SERVICE

## Model 225/232/235

## Bearing holder, 502 19 51-01

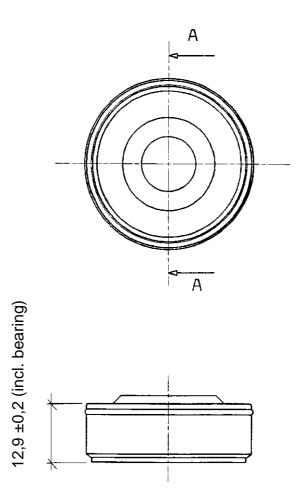
When mounting bearing holder to ballbearing be observant to have the bearing all way down in the holder until you reach the shown measurement (12,9±0,2mm).

If not there will be axial force at the ball bearing which this type of bearing can not take.
